BID ADDENDUM #2

Bid # RFB-2022-15

SUNY SCCC WELCOME CENTER

C2 DESIGN PROJECT #2006

3 Enlarged Reflected Ceiling Plan At Reception
A801 SCALE: 1/4" = 1'-0"

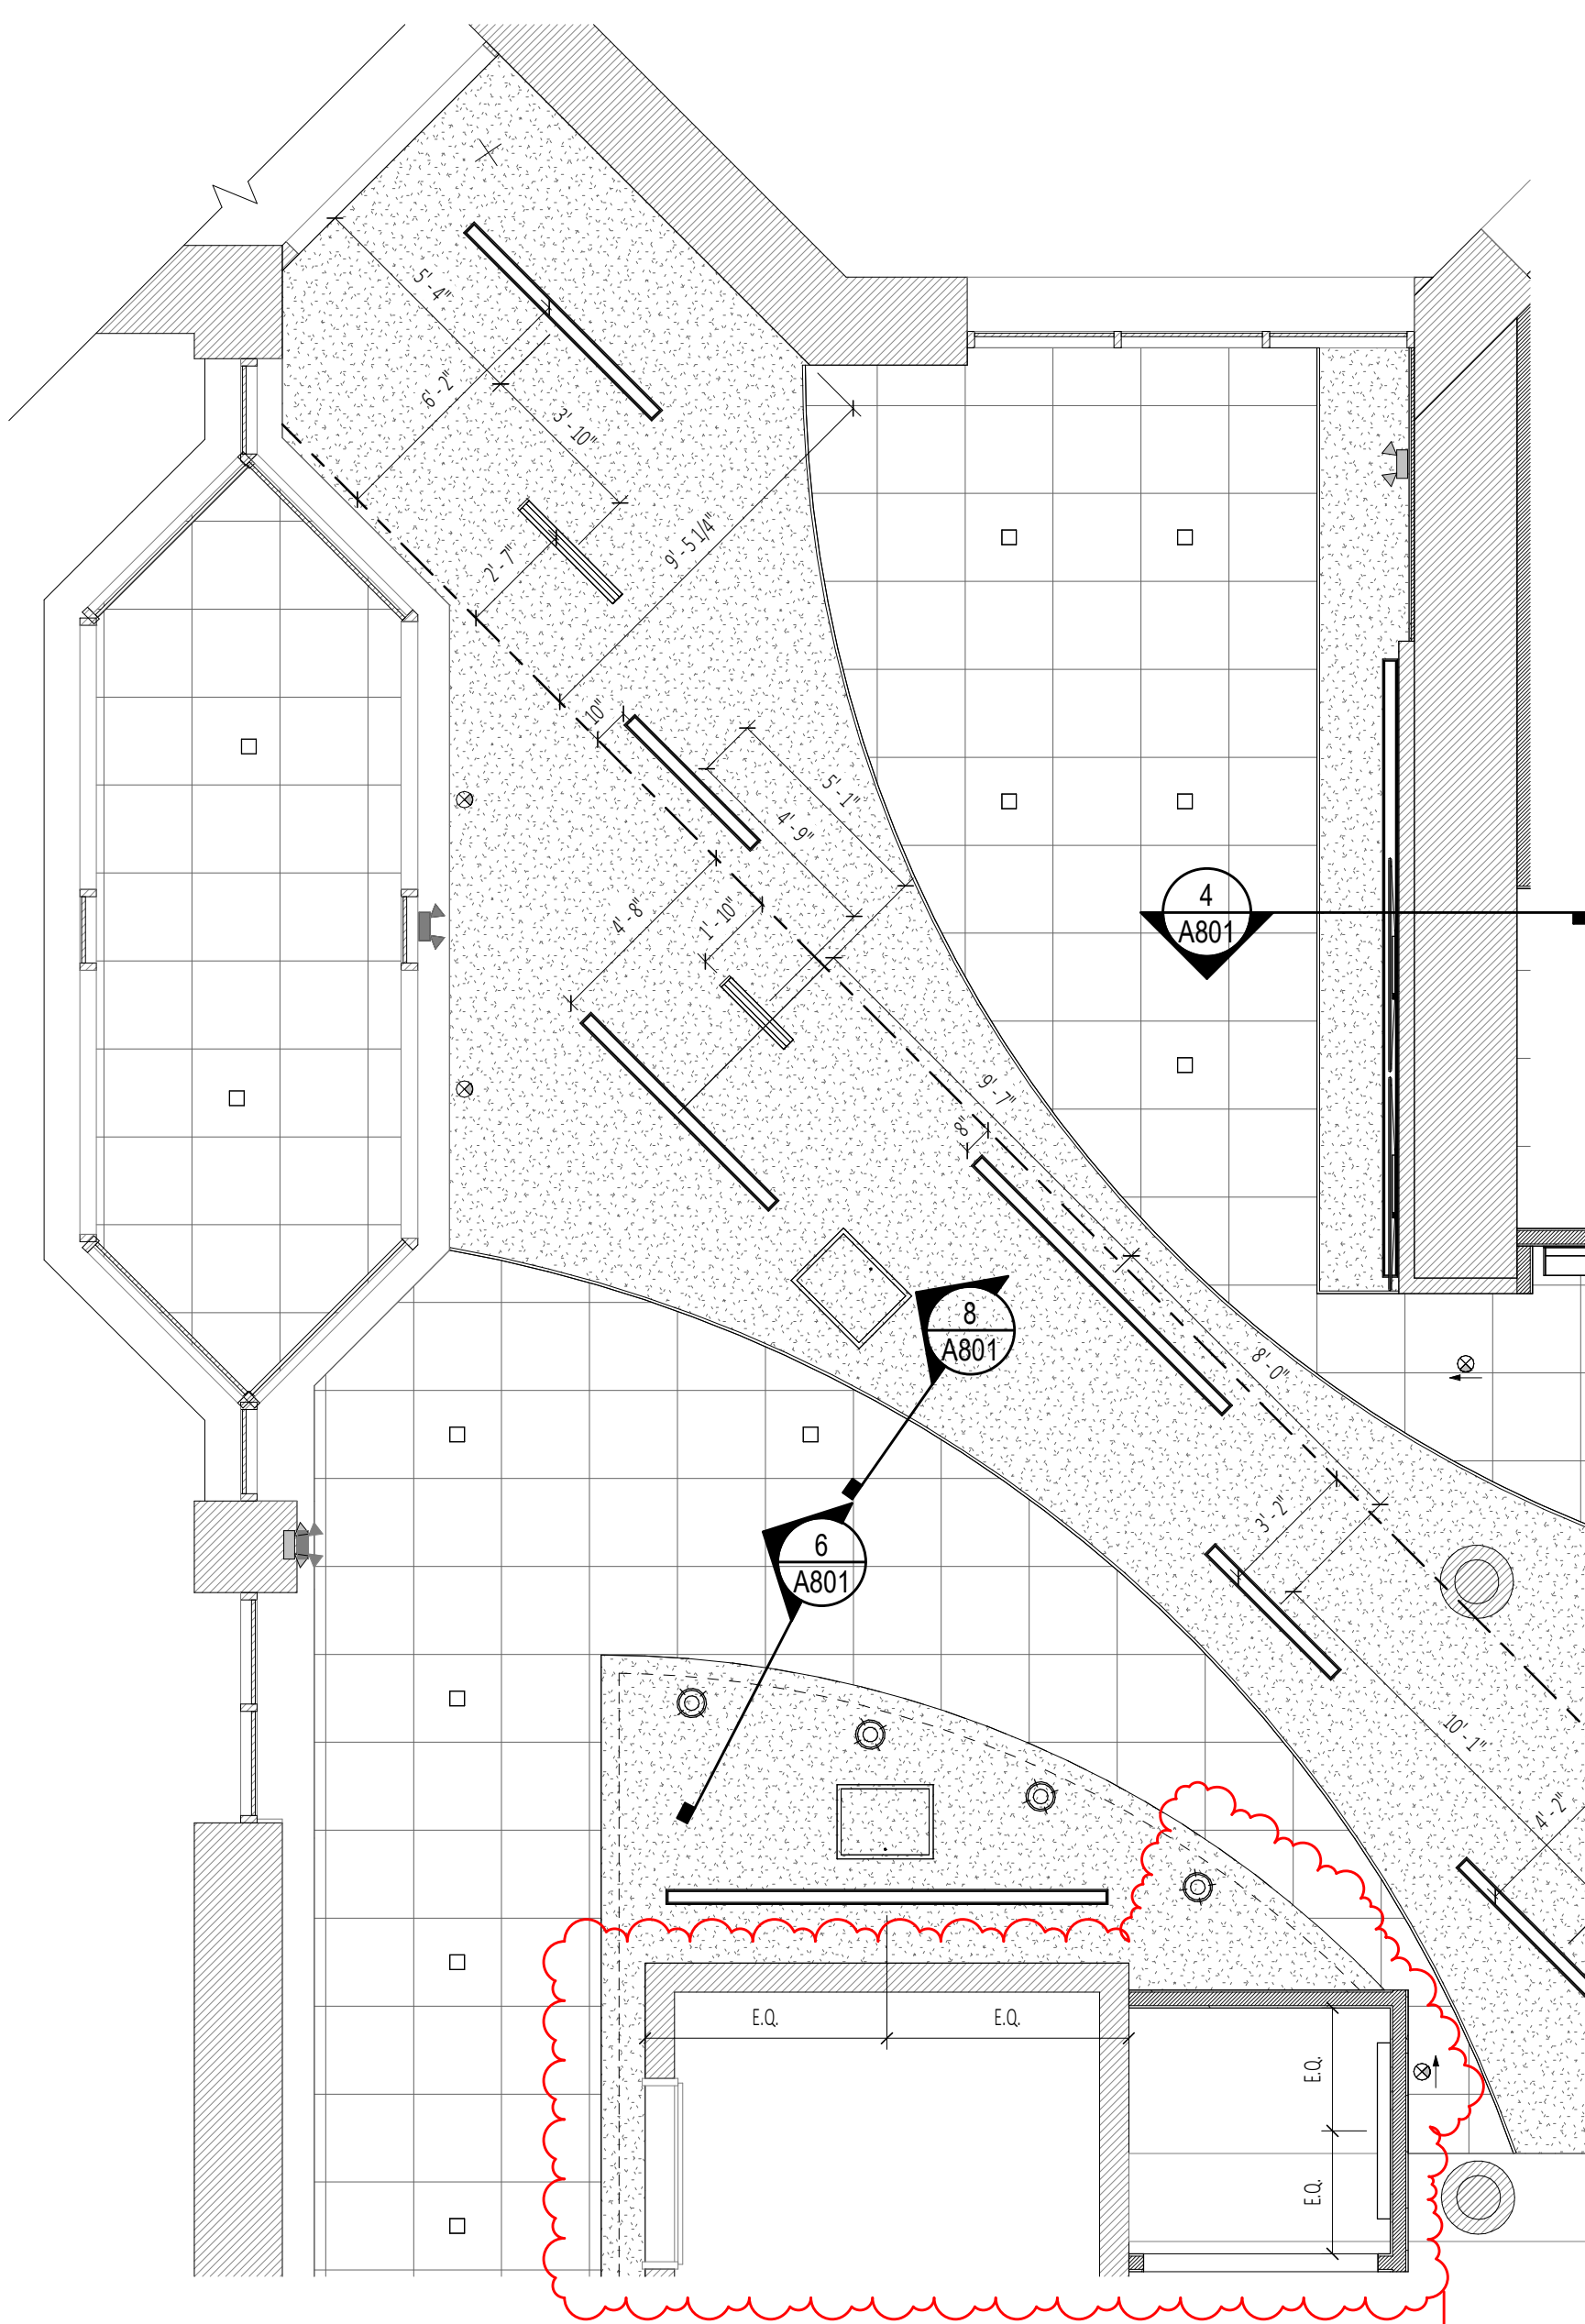
Drawing A801/Enlarged Reflected Ceiling Plan:

- Detail 1, 2, 3 Partial First Floor Reflected Ceiling Plans:
 - Revisions as noted.

1 Partial First Floor Finish Plan
SCALE: 3/16" = 1'-0"

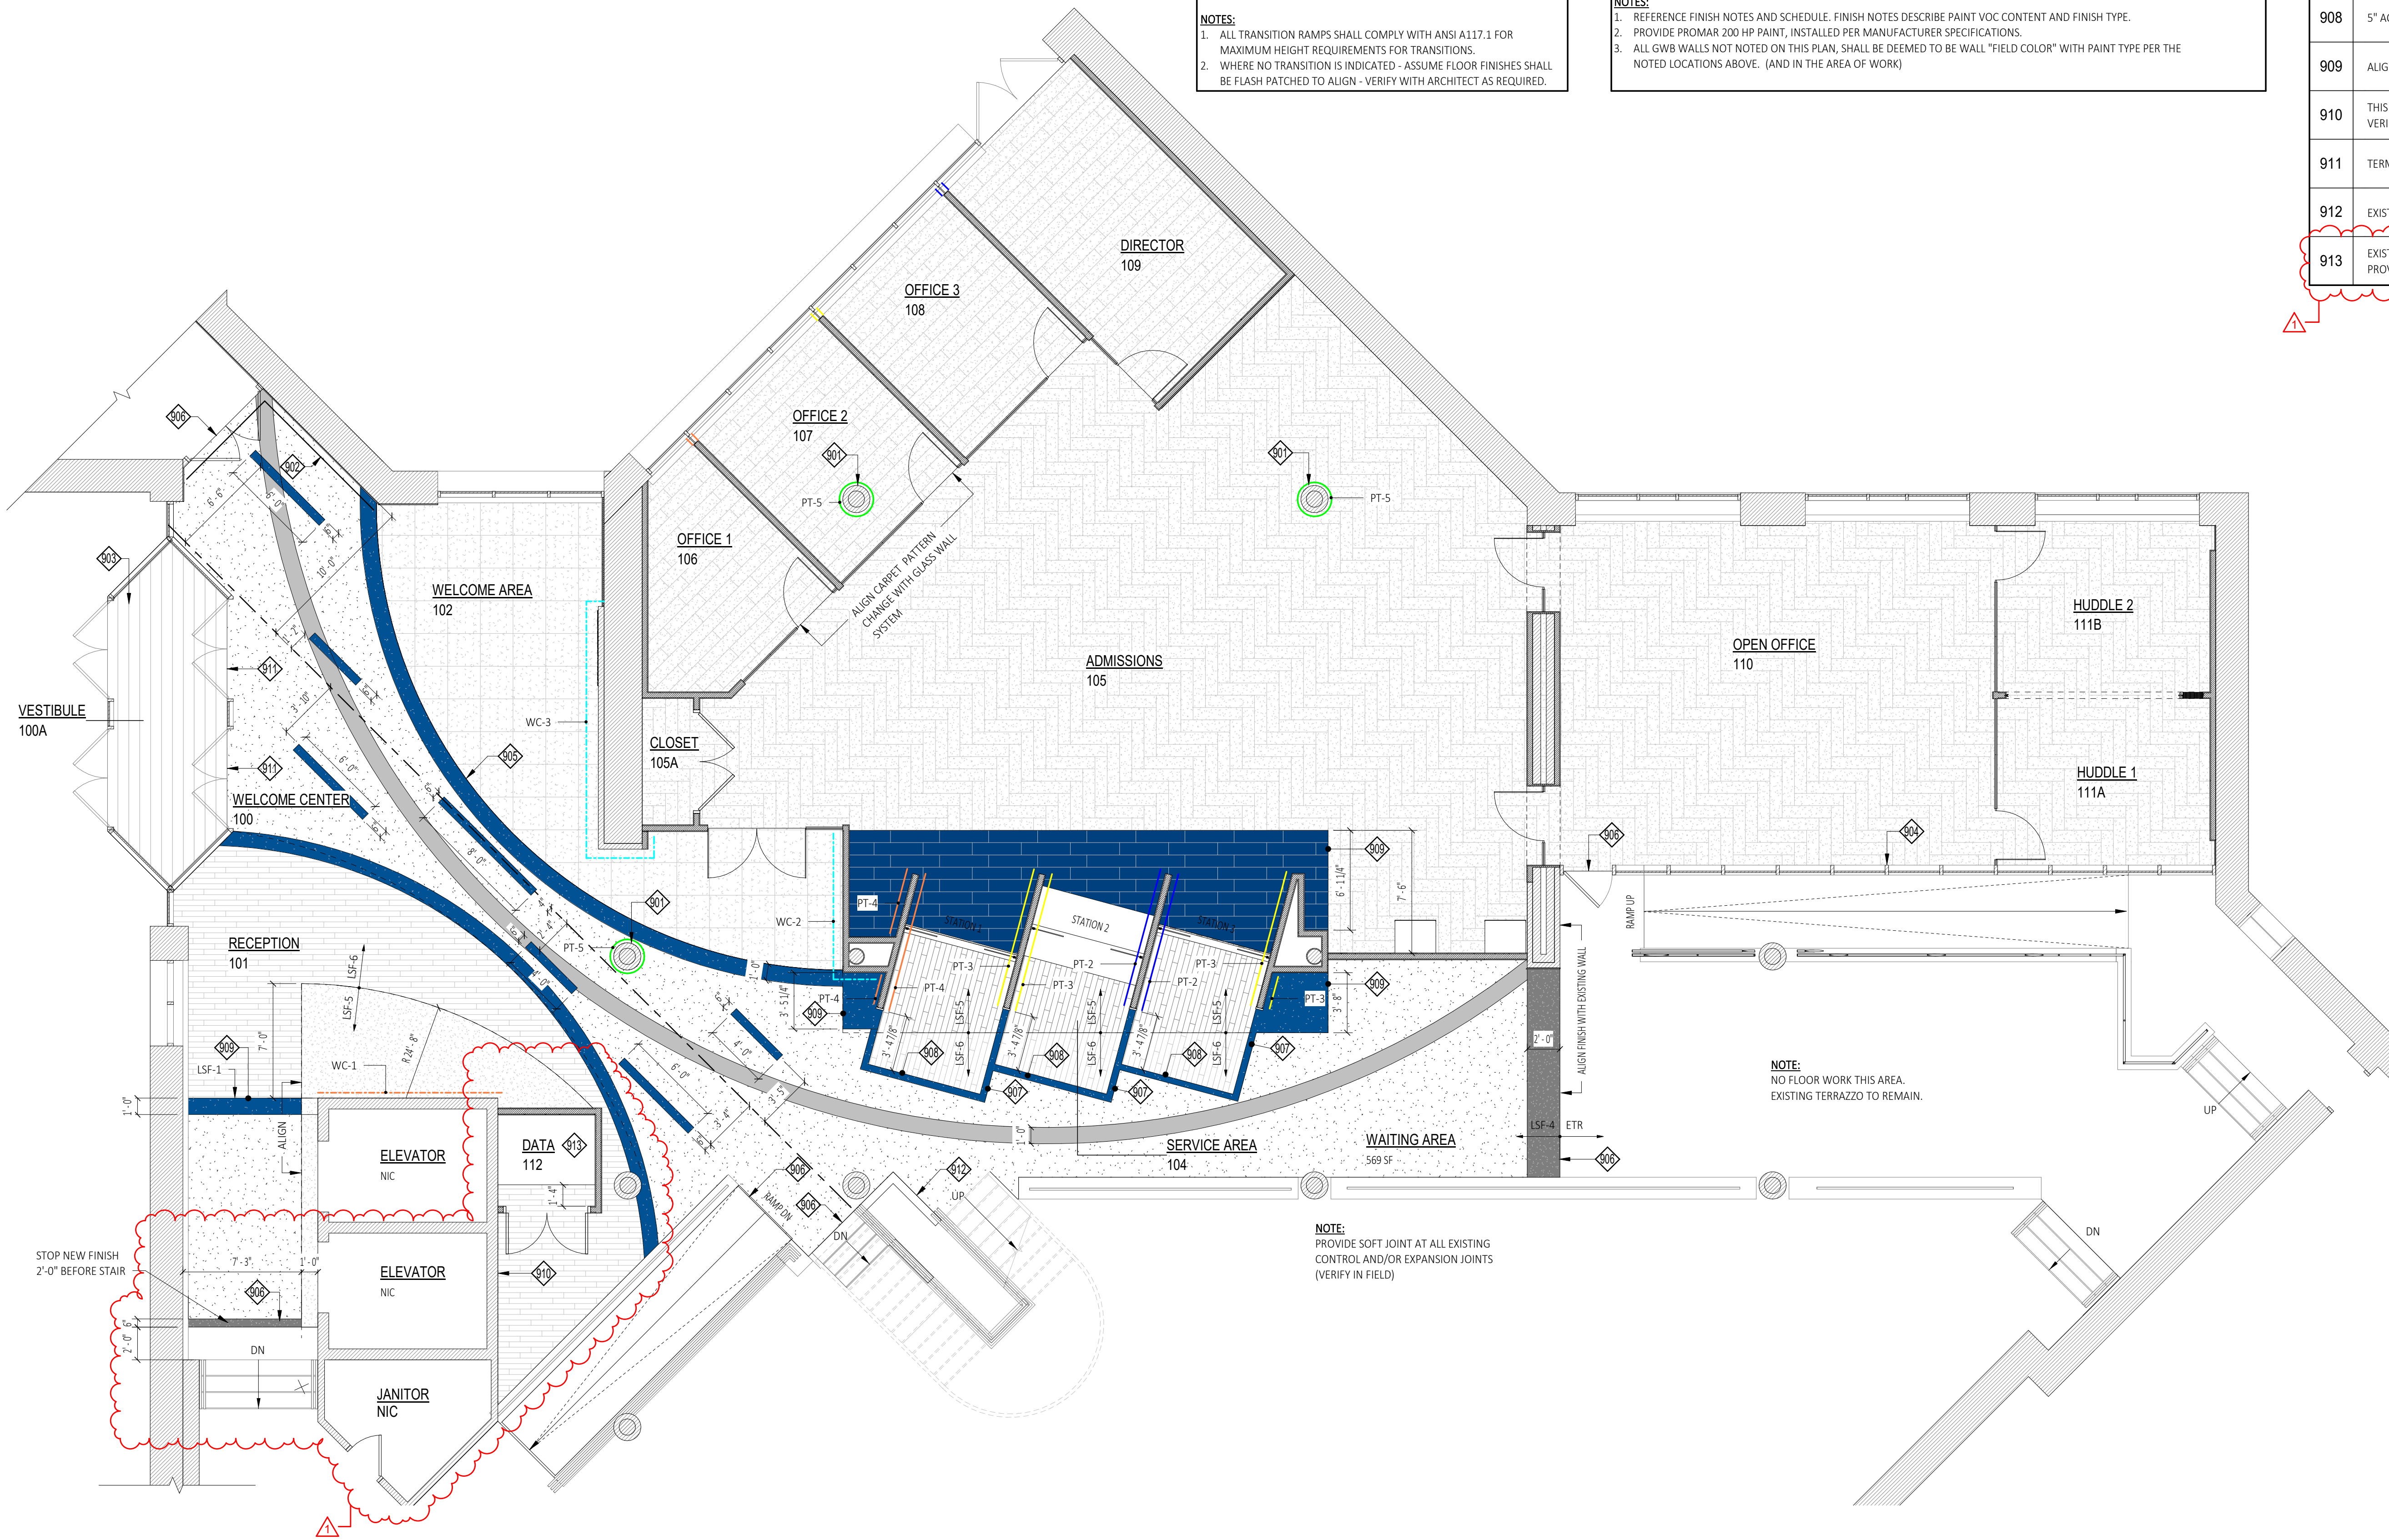
Drawing A902/Finish Plan:

- Partial First Floor Finish Plan:
 - Revision as noted.
- Finish Plan Keynote Legend:
 - Revision to key 913 as noted.

1 PARTIAL FIRST FLOOR PLAN
 E201 SCALE: 3/16" = 1'-0"

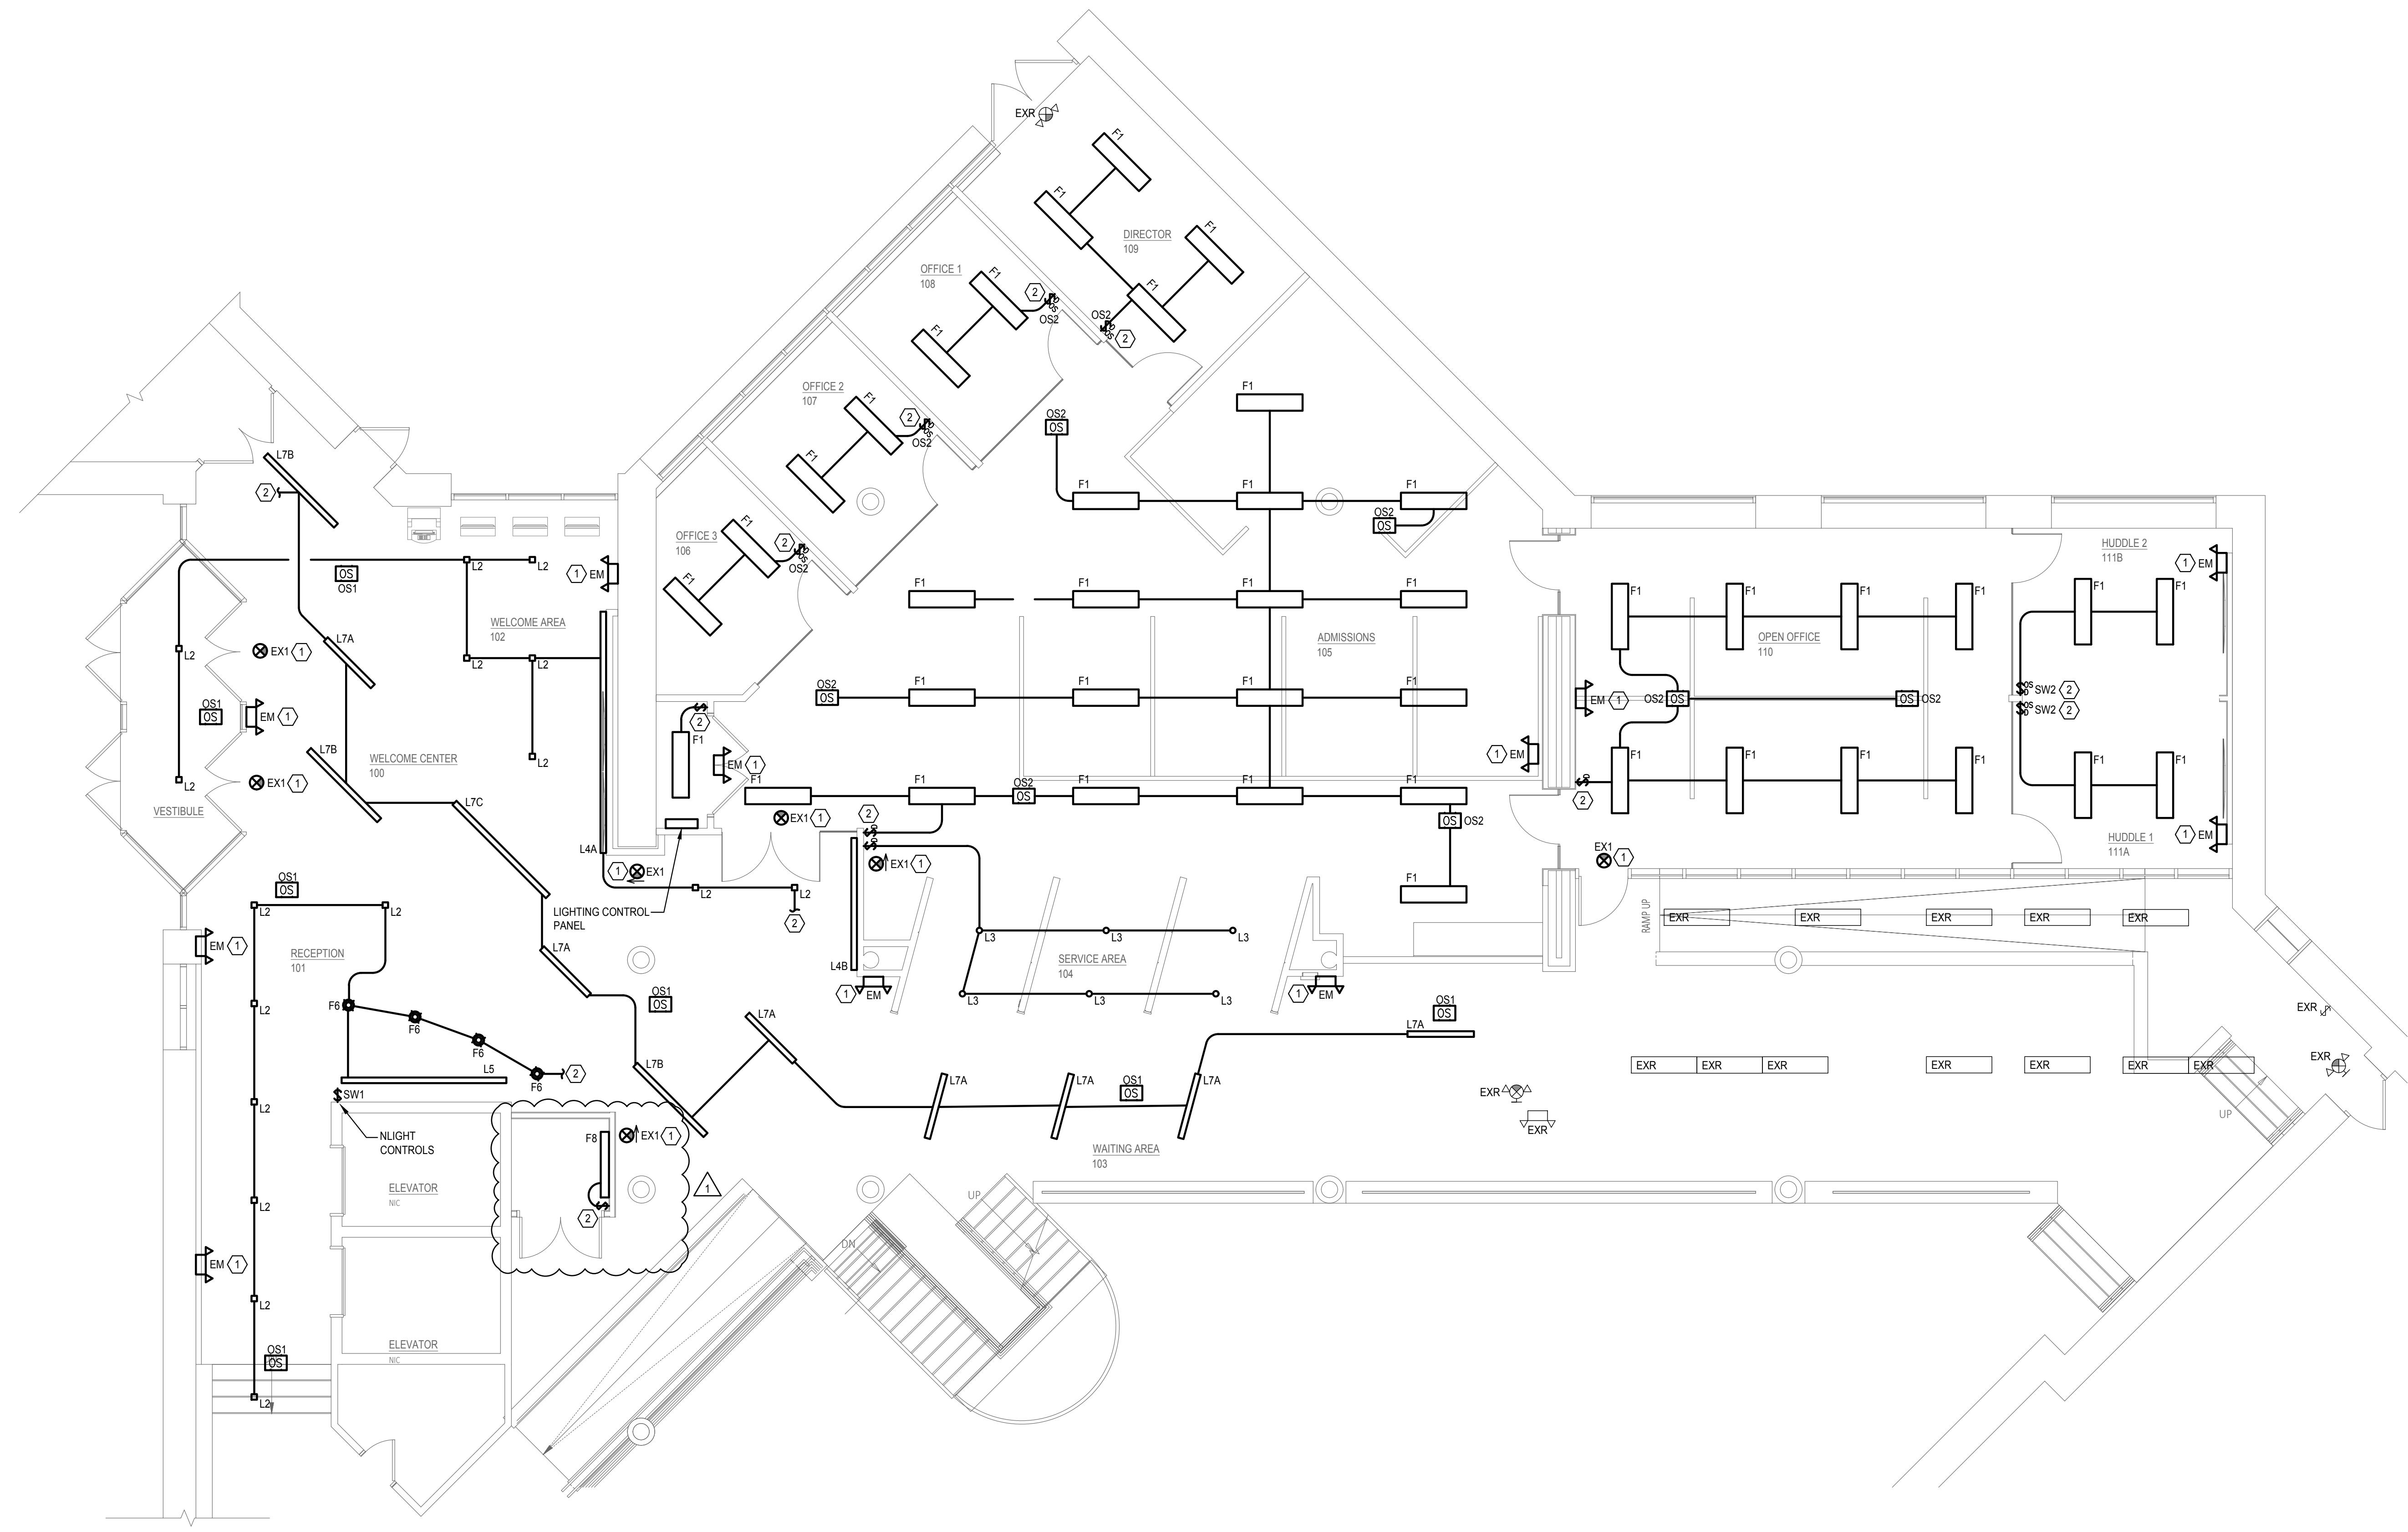
Drawing E201/ Partial First Floor Removal Plan:

- Detail 1, Partial First Floor Plan:
 - Revisions as noted.
- Removal Notes:
 - Revision as noted.
